U.S. Patent Application Serial No. 10/797,559 Amendment filed December 27, 2005 Reply to OA dated September 29, 2005

AMENDMENT TO THE DRAWINGS:

REMARKS

F1G. 2

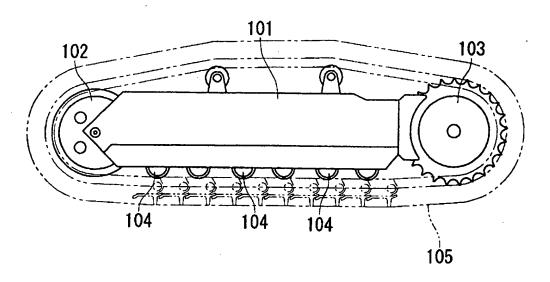
In Fig. 2, reference number 14 and the reference line thereof have been made clear.

<u>First</u>, submitted herewith are replacement sheets for Figures 15 - 17 labeled as "Prior Art". <u>Second</u>, with respect to the Examiner's objection (item 5, page 3 of the outstanding Action) concerning reference number 115, the applicants submit that reference number 115 is referred to as a peripheral groove, as discussed in lines 12 - 13, page 2 of the applicants' original specification. <u>Third</u>, with respect to reference number 14 (as noted in item 6, page 3 of the outstanding Action), such reference number 14 is referred to as a supply passage in the sentence bridging pages 8 and 9

of the applicants' specification. As such, the applicants' Figure 2 has been corrected so as to draw

reference number 14 (and the reference line thereof), located on the right hand portion of the

applicants' Figure 2.

FIG. 15 PRIOR ART

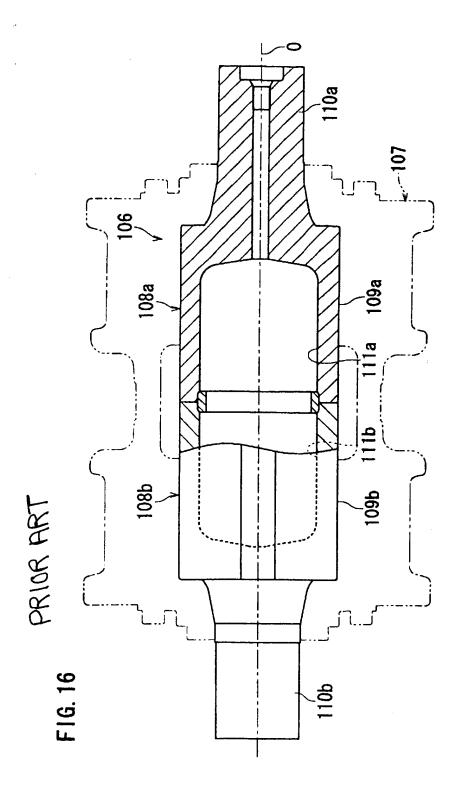
Each of Figs. 15 - 17 have been labeled as "Prior Art".
